Title: Science - CAN

UW Robotics  
200 University Avenue  
Waterloo  
Ontario  
Canada N2L 3G6

## 5V - 3.3V LDO

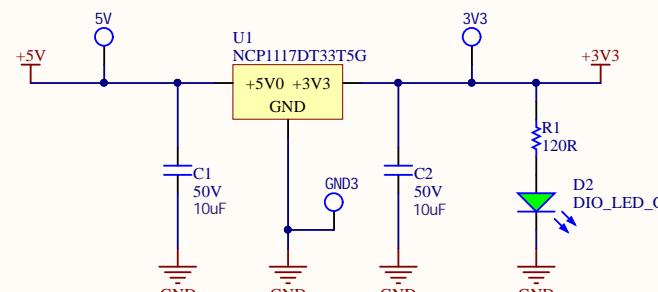
- V2: Replace LDO with an LDO with less ESR requirements  
- Explore adding bulk capacitor

## Consolidated connectors

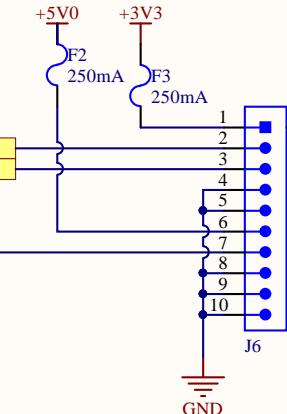
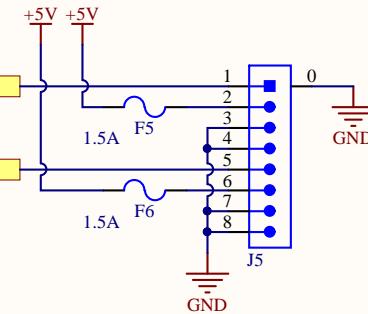
need to wire  
connections for  
endoders motors  
& can

Mistakes were made  
on counting the pins.  
This 10 long should  
be 9 pin long

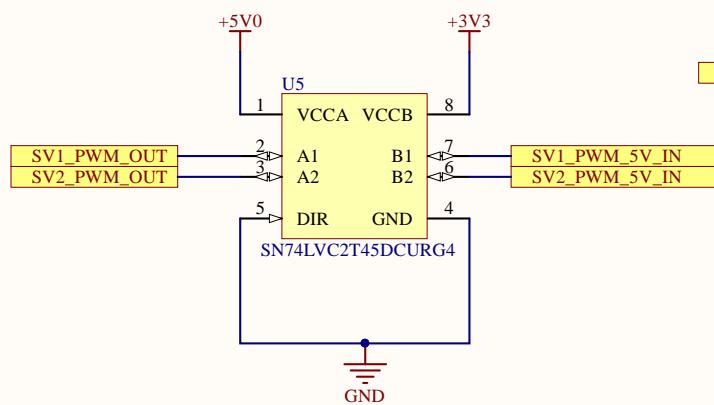
RC filter for PWM server encoder. Needs to be changed
